**The Philadelphia Parking Authority
Mellon Independence Center
701 Market Street, Suite 5400
Philadelphia, PA 19106**

**Bid No. 16-06 – Provide and Install Bird Control Netting
Philadelphia International Airport
Addendum One**

SECTION THROUGH CANOPY

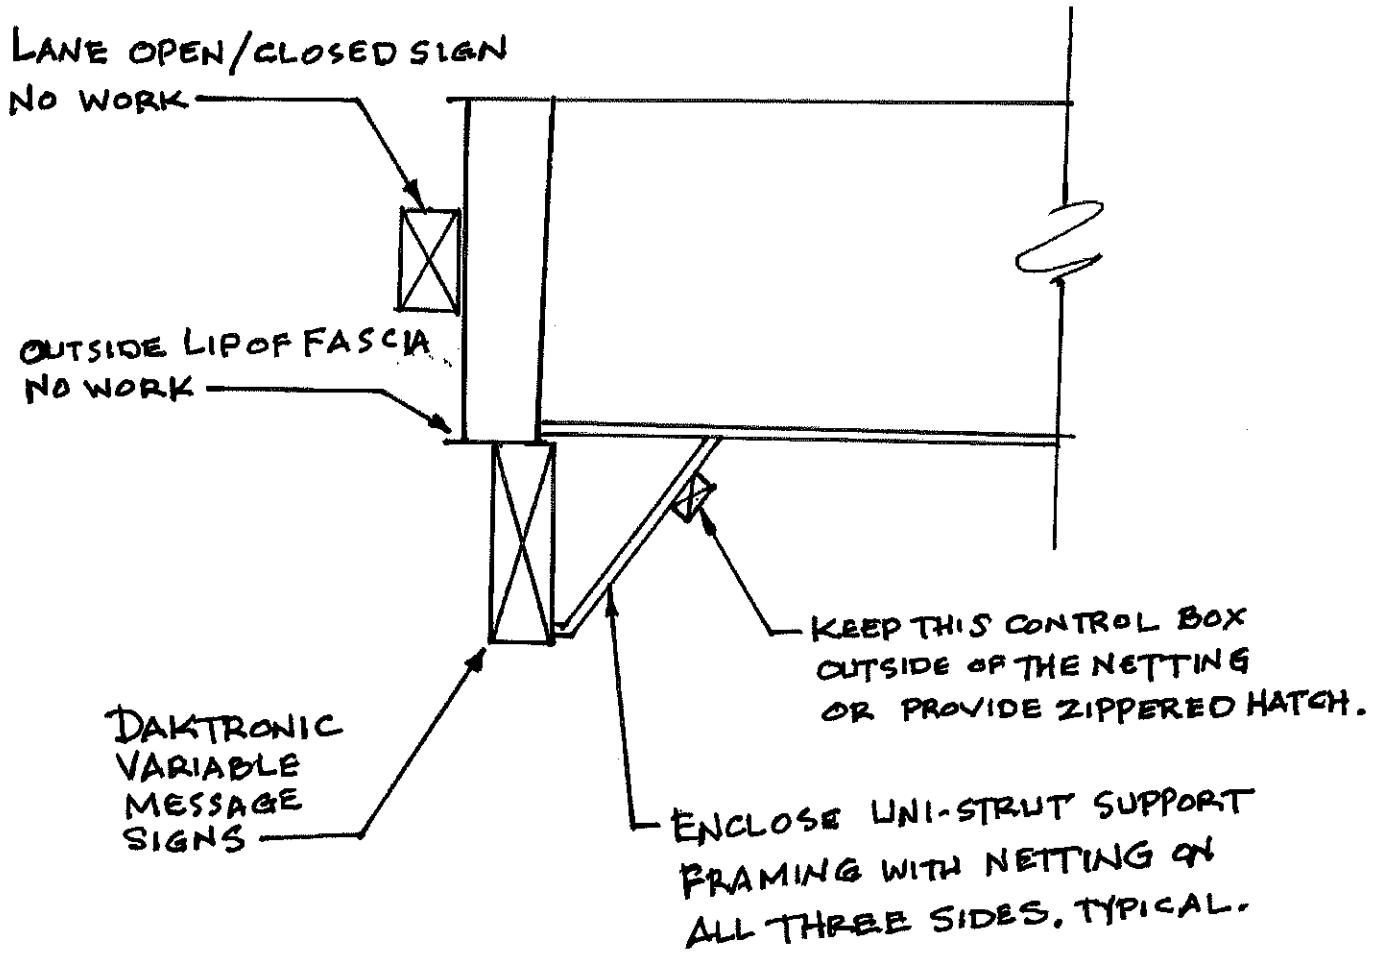
1. **Question:** The outside ledge of the canopy fascia, at the bottom; do you want that outside ledge protected? Also, the open/close lane signs (the birds can sit on them), and any other signs that are on that face, do you want them protected?
The longer, rectangular signs that are down below, do you want them protected also?

Enclose the uni-strut support framing with bird netting on all three sides.

Keep the smaller control box outside of the netting or provide a zippered hatch in order to maintain access to the box.

The outside ledge of the canopy fascia is not included.

The open/closed signs on the fascia are not included.

For the larger Daktronic Message signs which are attached to the bottom of the canopy, contractor shall enclose the uni-strut support framing with bird netting on all three sides. Keep the smaller control box outside of the netting or provide a zippered hatch in order to maintain access to that box.
